HISTORIC AND DESIGN REVIEW COMMISSION

Agenda Item No: 9

HDRC CASE NO: 2016-390
ADDRESS: 227 ADAMS ST
LEGAL DESCRIPTION: NCB 942 BLK 1 LOT E 95 FT OF 7
ZONING: RM-4 H HS
CITY COUNCIL DIST.: 1
DISTRICT: King William Historic District
LANDMARK: Schulze, Otto - House #1
APPLICANT: Bob Bradley/Bradley Design
OWNER: Richard Green, Nora Peterson
TYPE OF WORK: Modifications to existing accessory structure
REQUEST:

1. Replace the flat roof of the rear accessory structure with a gable roof and standing seam metal
2. Replace existing non-historic door with new front door
3. Install galvalume metal gutters

SHT
A-3
OF 6

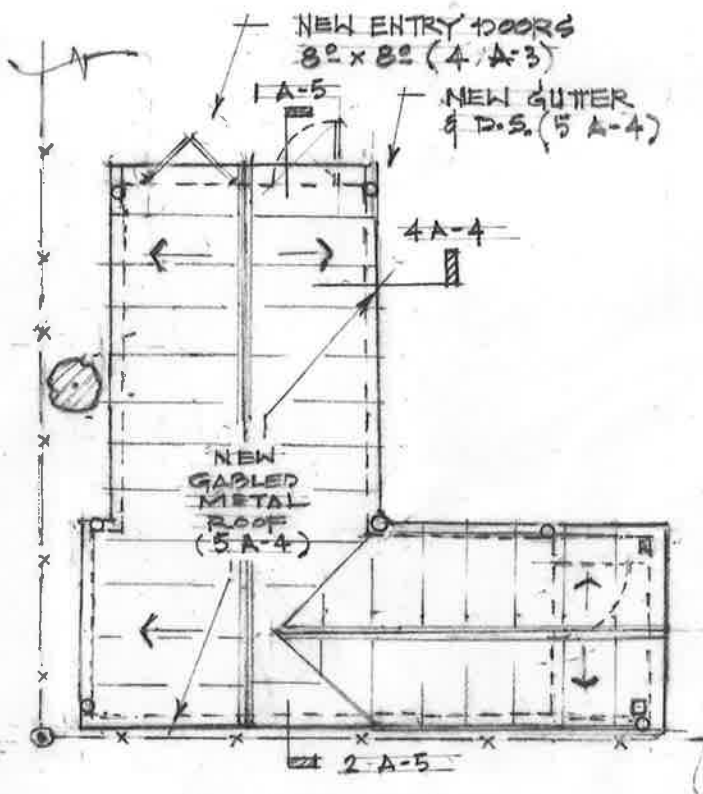
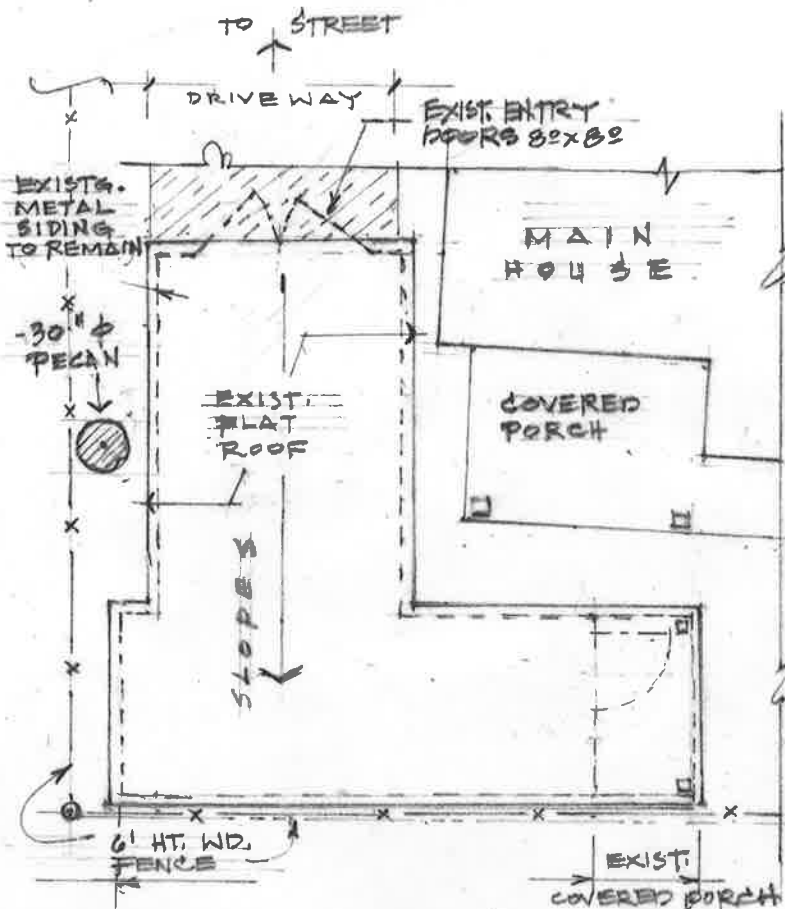
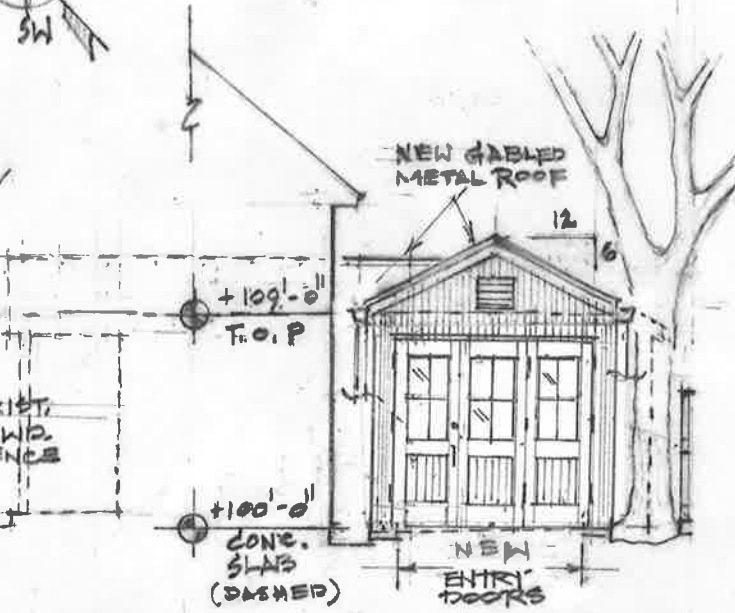
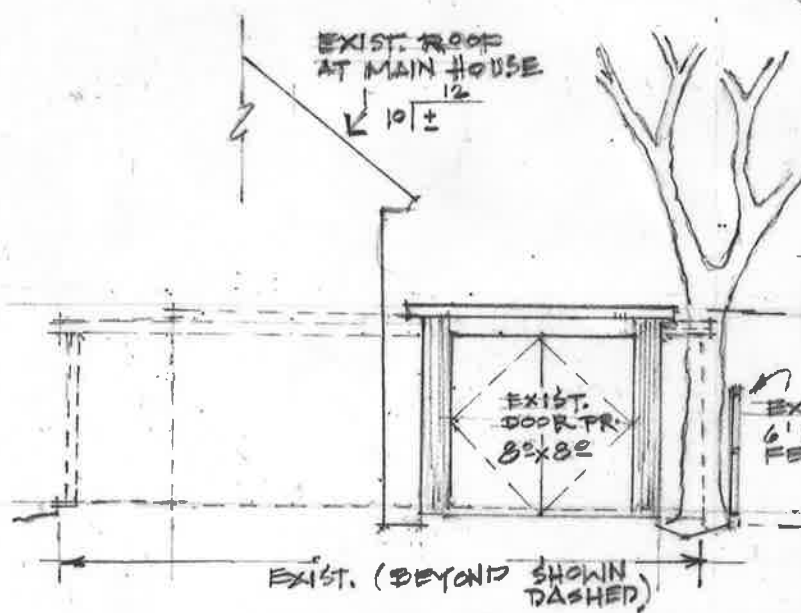
- c. The applicant is proposing to add a cross gable on the exiting L-shaped accessory structure. The proposed roof will also have standing seam metal roofing. According to the Guidelines garages and outbuildings should relate to the period of construction of the principal structure. Staff finds the cross-gabled roof complements the cross-gabled roof of the main structure, thus the proposal is consistent with the Guidelines.

- d. The existing structure does not have gutters. The applicant is installing galvalume metal gutters to match the proposed metal roof. Staff finds the proposed gutters appropriate.

Staff recommends approval based on findings a through d with the stipulations that the standing seam metal roof panels are 18 to 21” in width, seams are a crimped ridge, and there is no ridge cap vent or end cap.

1912 Sanborn

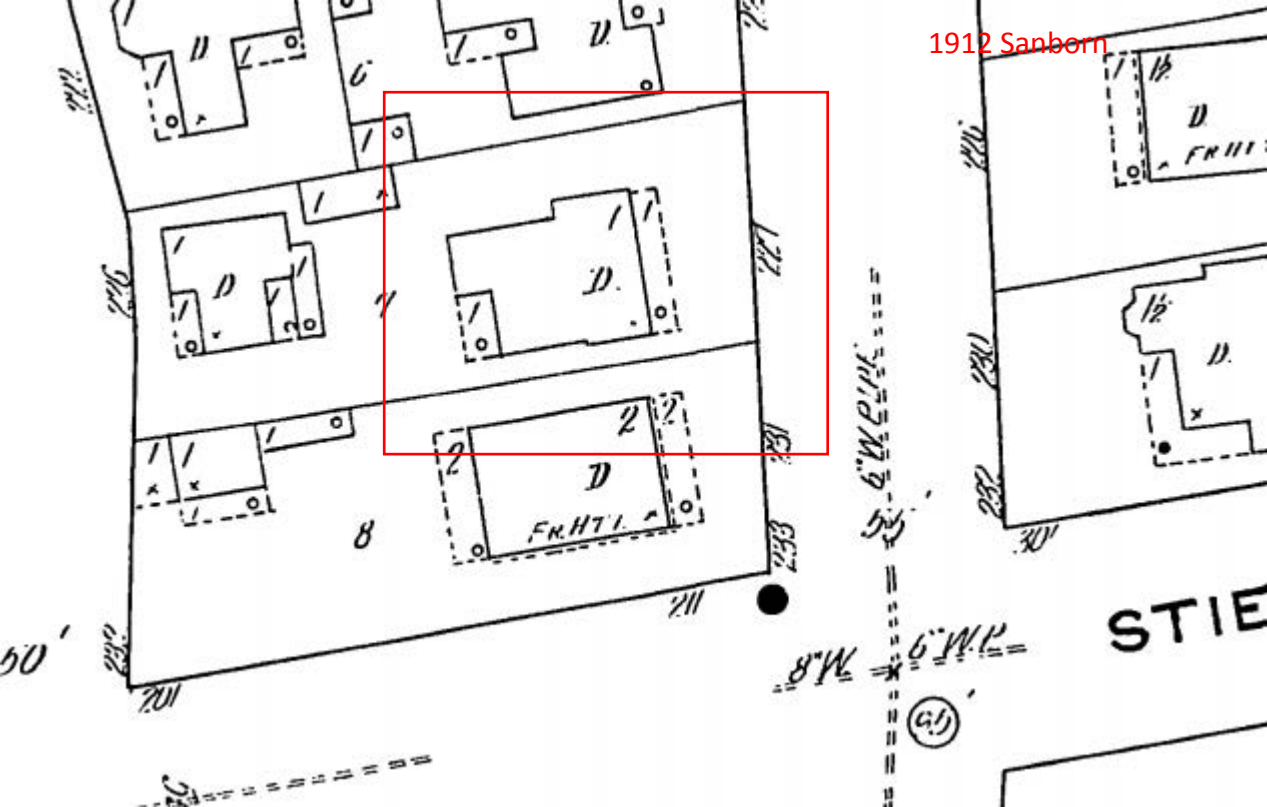
- a. The home at 227 Adams is in the King William Historic District, designated in 1968. The main structure is a folk Victorian with a cross-gabled roof, standing seam metal, a front French double door and 2 over 2 wood windows. There is an existing rear accessory structure is L-shaped with double doors made of plywood, corrugated metal siding, existing covered porch on southeast elevation and a flat roof. Staff did not find the rear accessory structure present on the 1912 Sanborn map, but found a smaller accessory structure than existing on the 1921 Sanborn map. Staff finds the existing rear accessory structure is not original to the site.
